PLANNING, ZONING, & BUILDING DEPARTMENT  
PZ&B Staff Memorandum: Architectural Commission

FROM: Wayne Bergman, Director, MCP, LEED-~~AP~~<sup>WRB</sup>  
SUBJECT: ZON-24-017 (ARC-24-007) 222 WORTH AVE (COMBO)  
MEETING: APRIL 24, 2024, ARCOM

**ARC-24-007 (ZON-24-017) 222 WORTH AVE (COMBO).** The applicant, Louis Vuitton America, has filed an application requesting Architectural Commission review and approval for exterior façade alterations, including a new ground floor storefront system, awnings, and new signage. This is a combination project that shall also be reviewed by the Town Council as it pertains to zoning relief/approval.

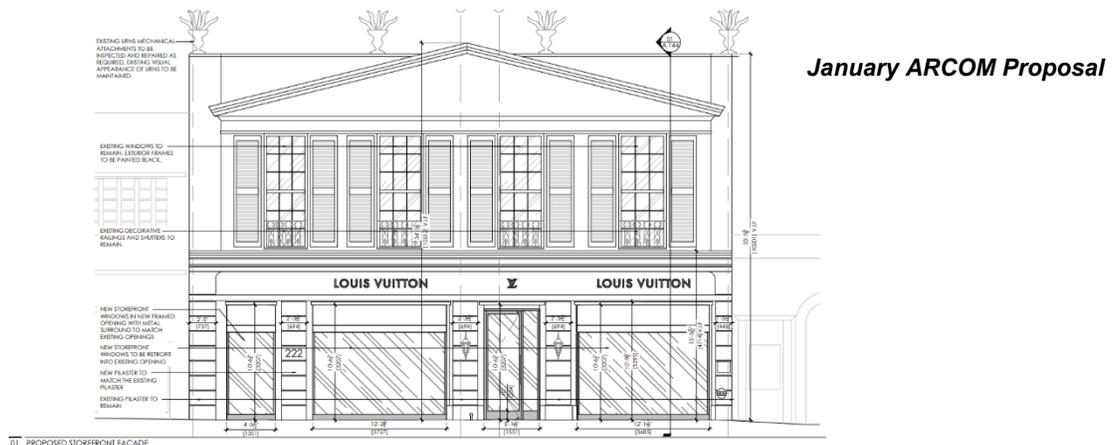
At the January 24, 2024, ARCOM meeting, the applicant presented a scope of work that would replace the two existing glass and frame systems with new glass and frame systems with a black metal finish. A new entry door, a single door with sidelight with black metal and glass was proposed to be installed to replace the existing double door. New black awnings were also proposed, while the existing exterior lighting was programmed to remain. The most architecturally significant portion of the application was the alteration of the ground floor façade—specifically the removal of the arched window and door along the easternmost portion of the elevation to infill with a new glass and frame system to match the geometry of the existing stucco façade including pilasters in the façade with a smaller glass storefront system:

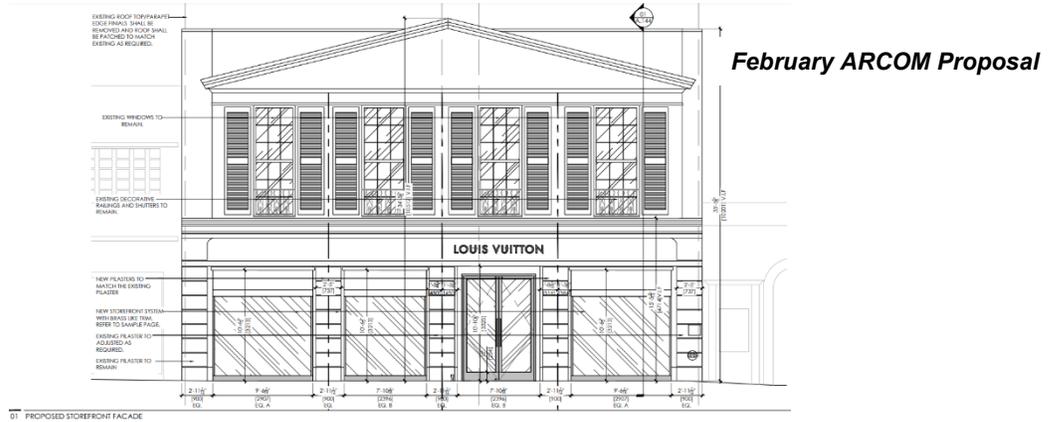
At the February 28, 2024, ARCOM meeting, the design modified the location of two existing pilasters to align more closely with the 2nd-floor façade. As a result, the storefront system was organized into three storefront bays with a brass finish. The front door design was also revised to a symmetrical double entry door with a brass finish. The awning color was revised to be white. The signage has been reduced to one sign above the entry doors. Based on the drawing from the 1950s, the decorative finials along the parapet were removed. As previously proposed, the arched window and door along the easternmost portion of the elevation were removed:

*April ARCOM Proposal*

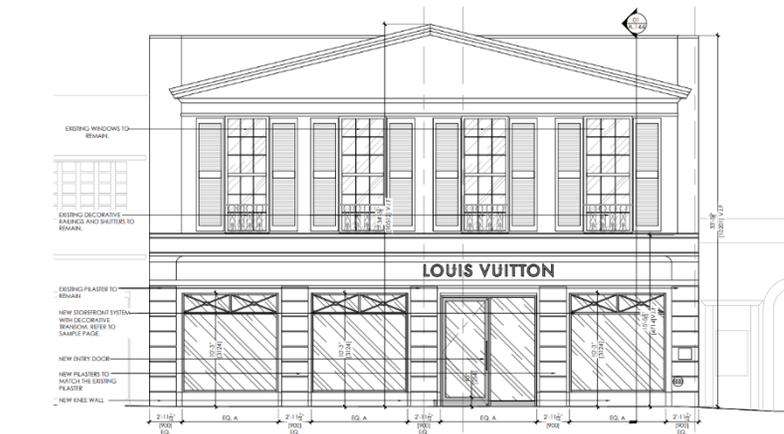
The latest revision modifies the location of the pilasters to create a storefront that is organized into four bays with a brass finish. The entry door has been recessed from the façade and is proposed with a single (equally sized) sidelight. The three remaining bays feature transoms and knee walls, as depicted in the original façade drawings. The signage is located above the entry door. The existing finials/urns will remain as described in the Letter of Intent although not depicted in the elevations and renderings. As previously proposed, the arched window and door along the easternmost portion of the elevation were removed:

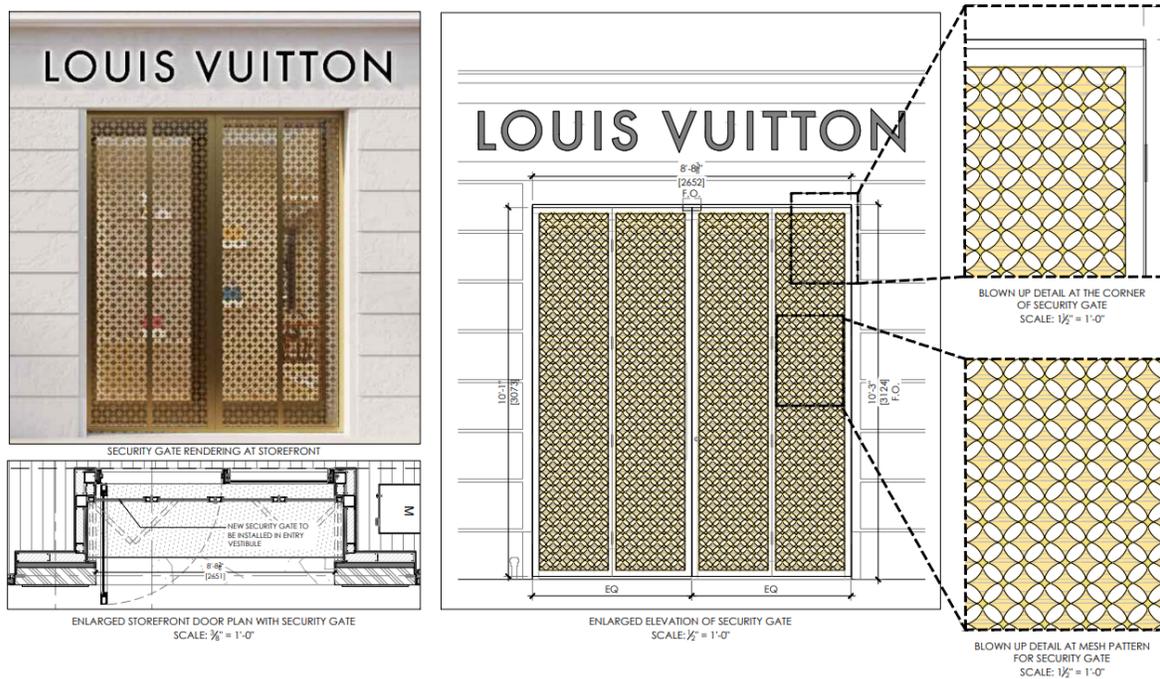
Finally, the security grill has been redesigned to be a bifold security gate in front of the new entry. Said steel gate will have a mesh pattern that allows for transparency into the store and provide for security

in a more aesthetically pleasing manner than a traditional roll down security gate.

Staff has some questions about the opaqueness and details of the bi-folding gate. Should the Commission find merit in the proposal, such design details could be handled as an administrative review in conjunction with the Chairman.
